July 29, 2014

Mr. Ryan Wulff
National Marine Fisheries Service
650 Capitol Mall, Suite 5-100
Sacramento, CA 95814

Re: Draft Bay Delta Conservation Plan and associated Draft Environmental Impact Report/Environmental Impact Statement Submitted by Nicole S. Suard, Esq. Managing Member, Snug Harbor Resorts, LLC

Figure VIII.1.1 DSM2 Calibration Web-Site

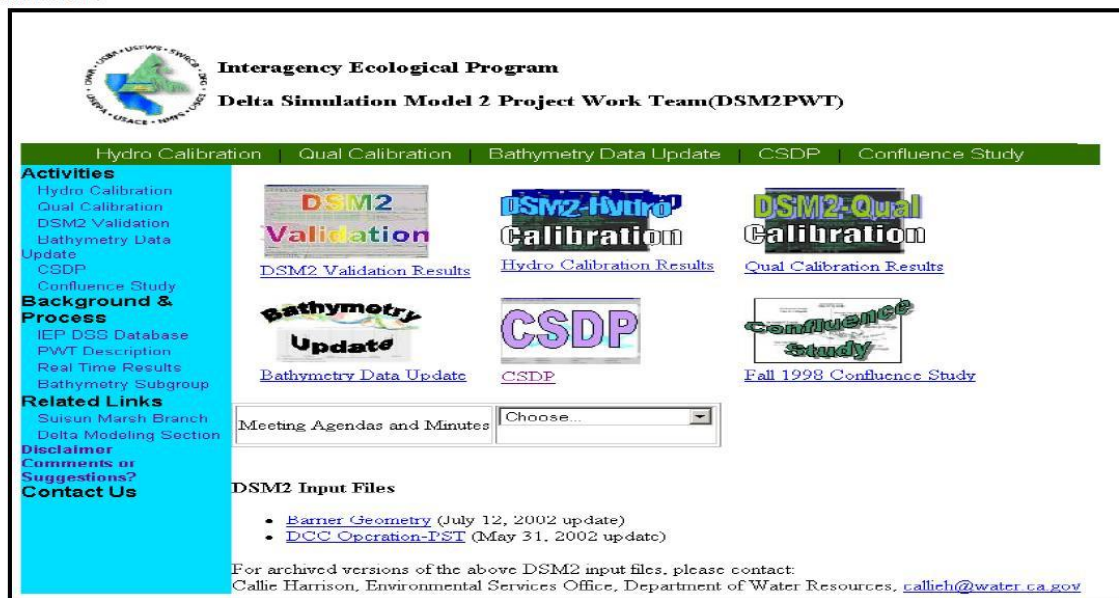
<http://www.iep.ca.gov/dsm2pwt/dsm2pwt.html> is where we're supposed to be able to validate...

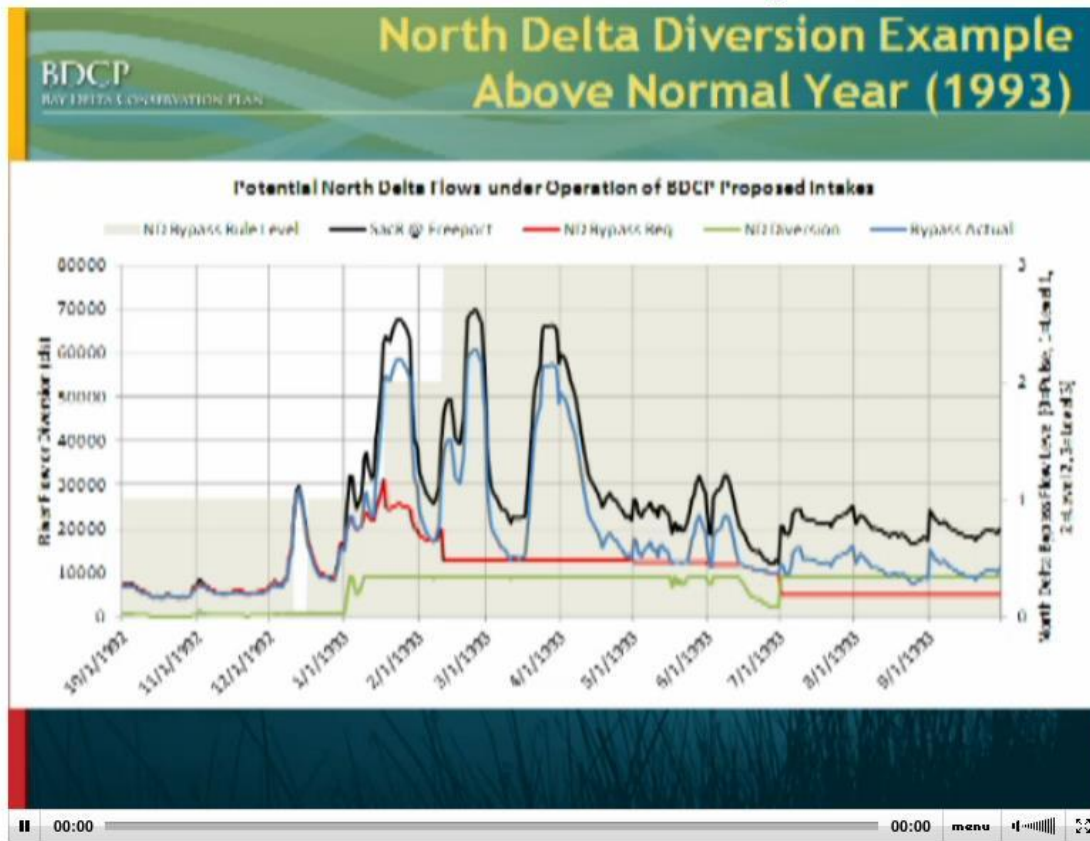
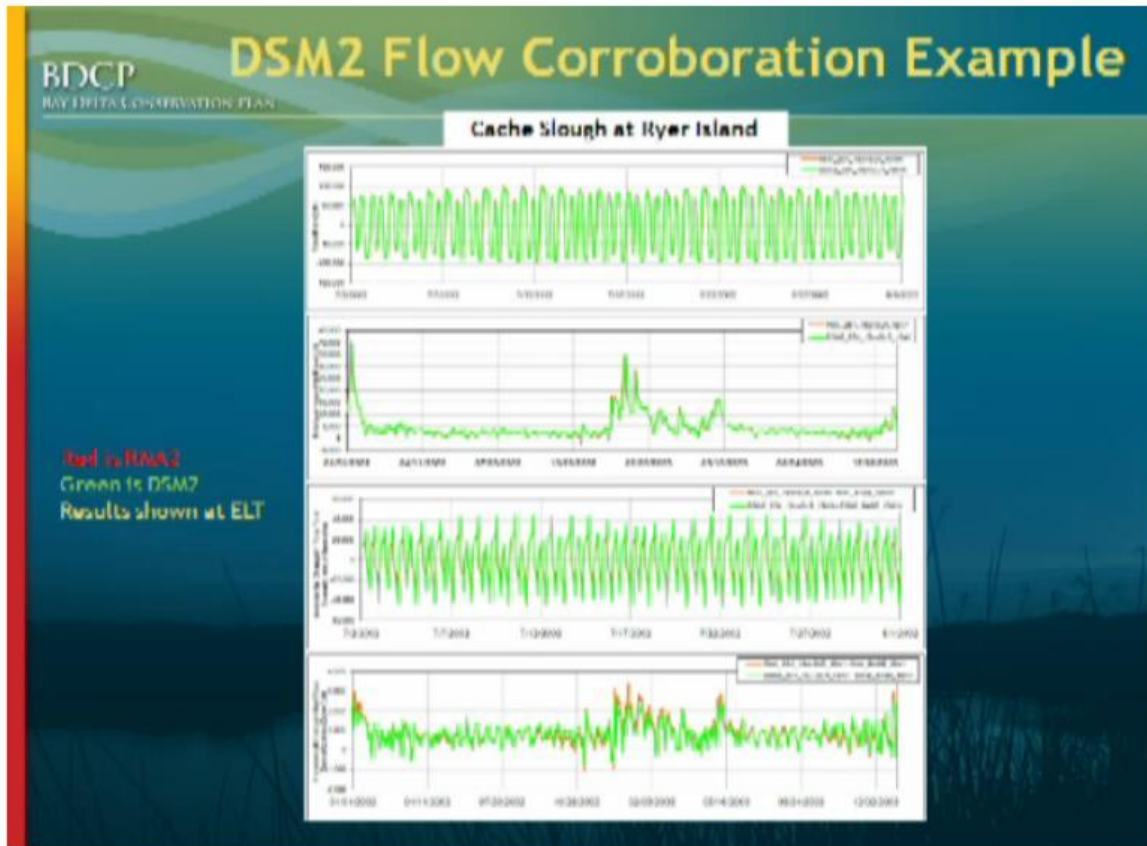
Which version of "Above Normal Year" does the modeling use? From CalSIM?

Segment 1
(P.M. 0.0/15.69)

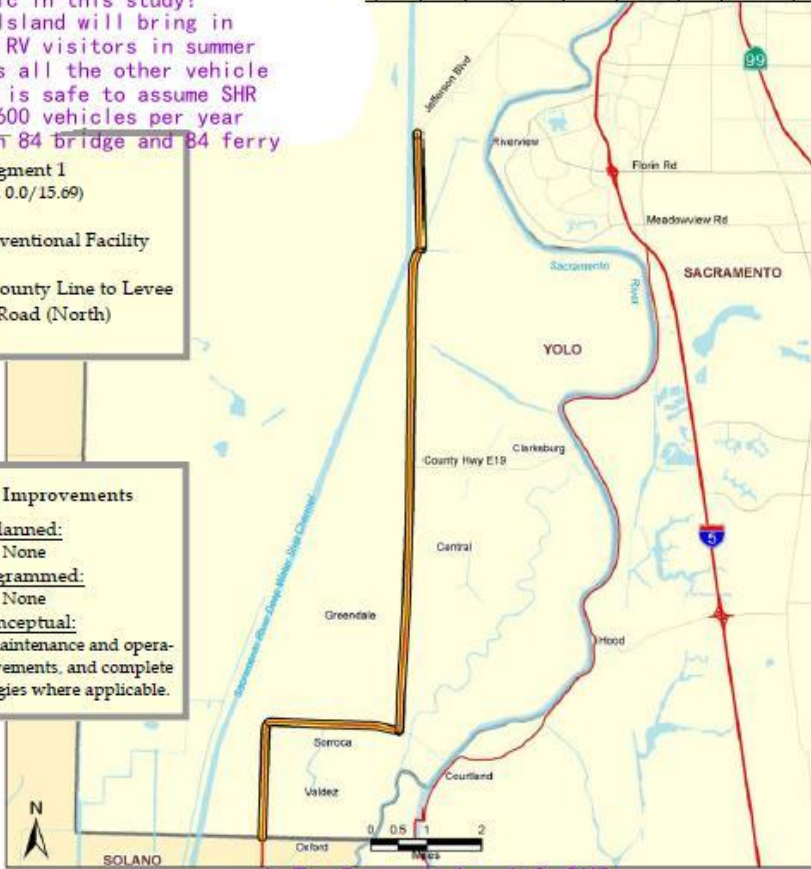
Calltrans is ignoring lots of annual traffic in this study! SHR on Ryer Island will bring in at least 800 RV visitors in summer season. Plus all the other vehicle traffic. It is safe to assume SHR alone adds 1600 vehicles per year split between 84 bridge and 84 ferry

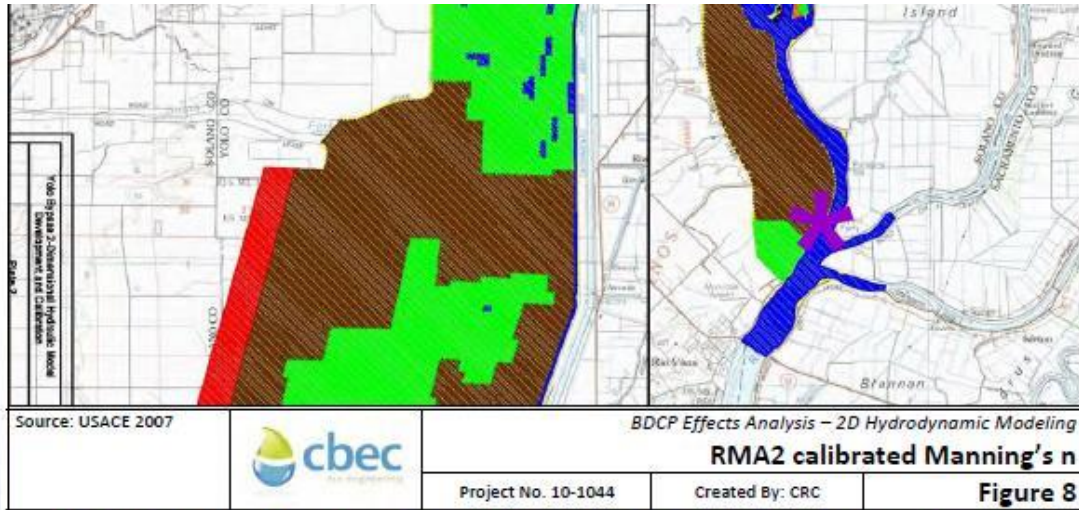
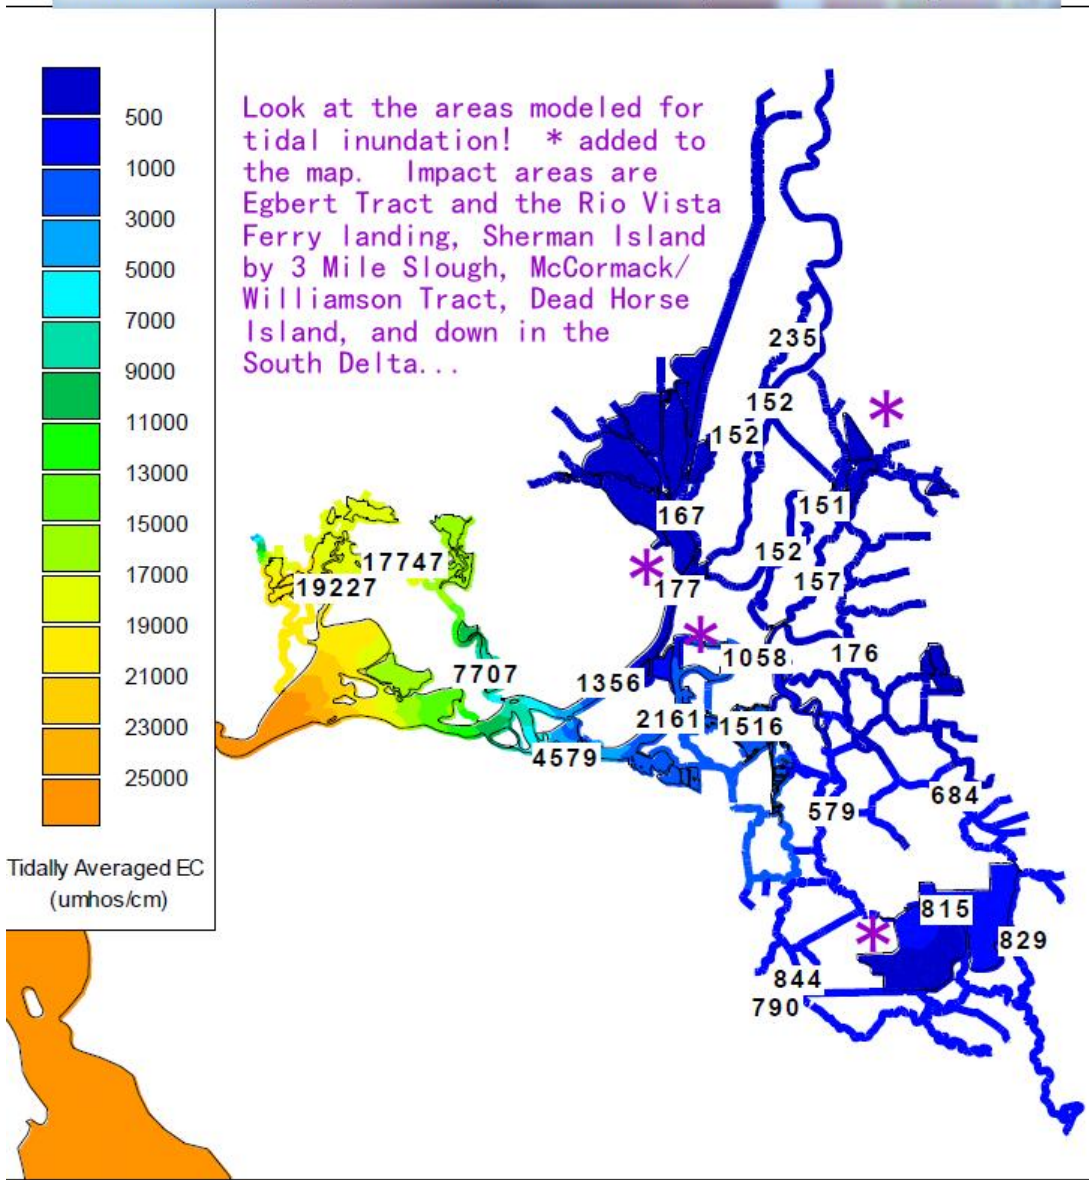
What happens to the ferry landing & SR 84 during flood times? Not disclosed by BDCP.

FIGURE 2-2
DSM2 Model Grid in the North Delta Showing the Grid Modifications
Performed as Part of the Recalibration Effort

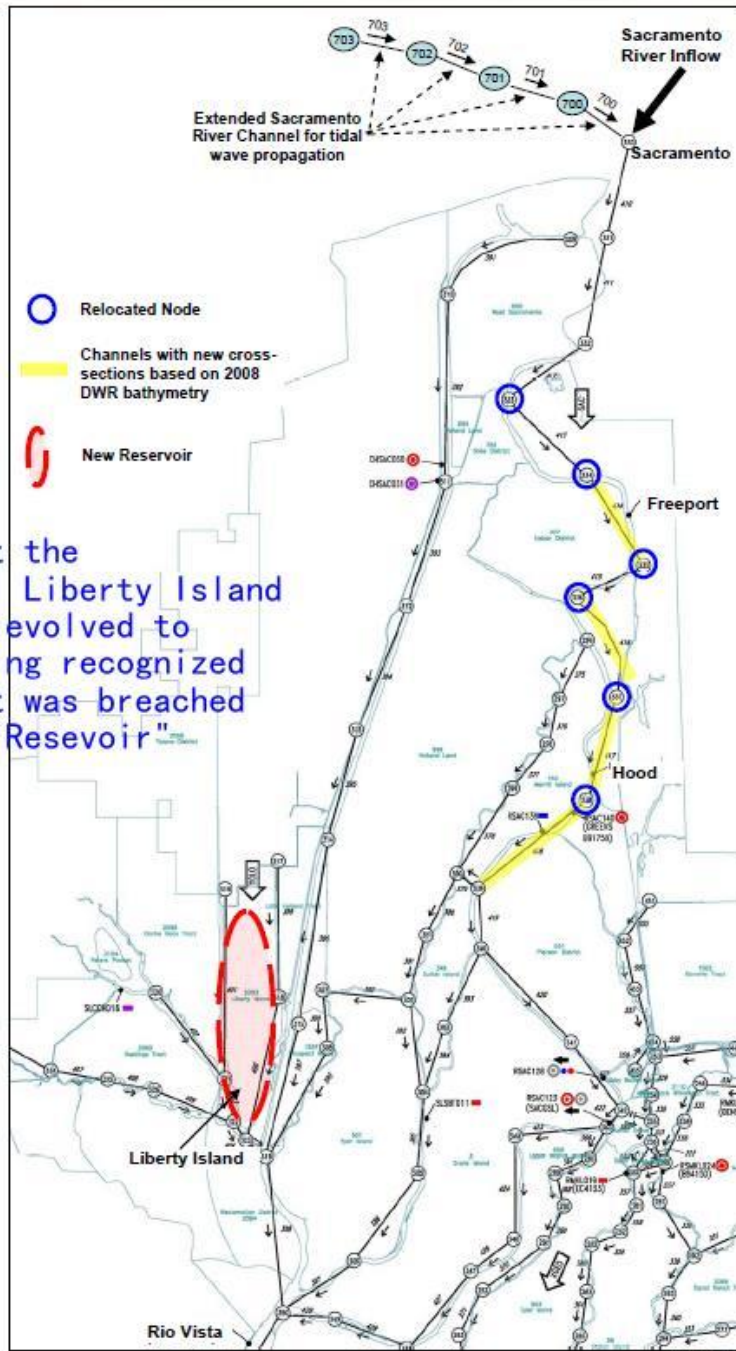
Notice that the
Accidental Liberty Island
breach has evolved to
finally being recognized
for what it was breached
for: "New Reservoir"
